**ADDENDUM #1 TO BID #22-066**

BID NUMBER: 22-066

**PROCUREMENT FOR: Gate and Access Control System for Landfill Entrance**

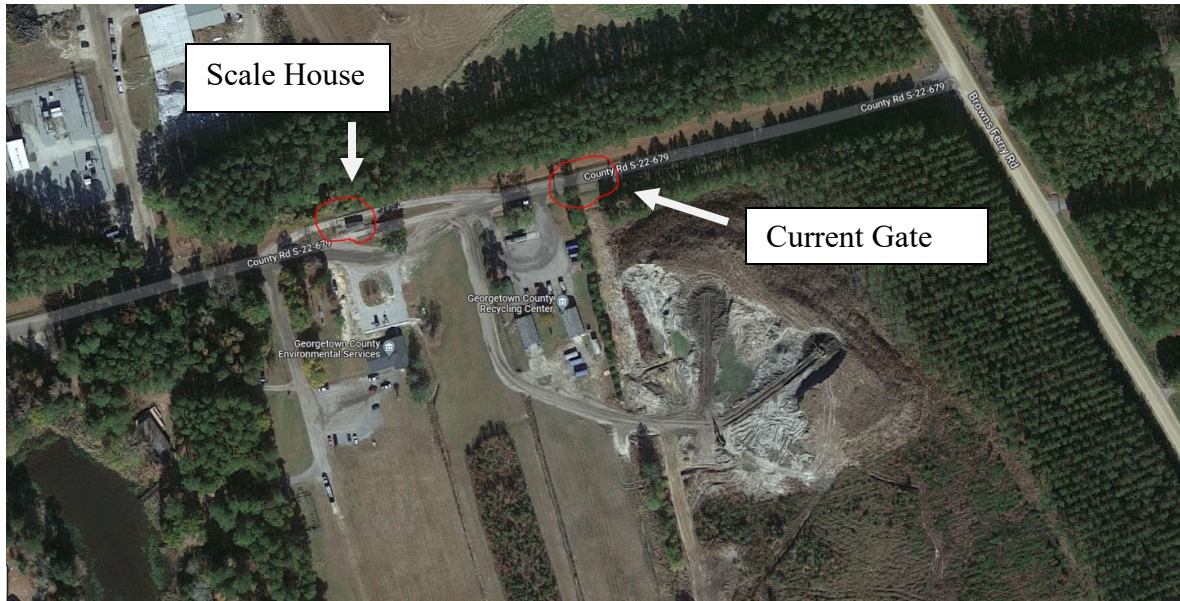
**Question 25:** Can you provide a google image identifying where the gate is and where the scale house is located?

**Answer:**
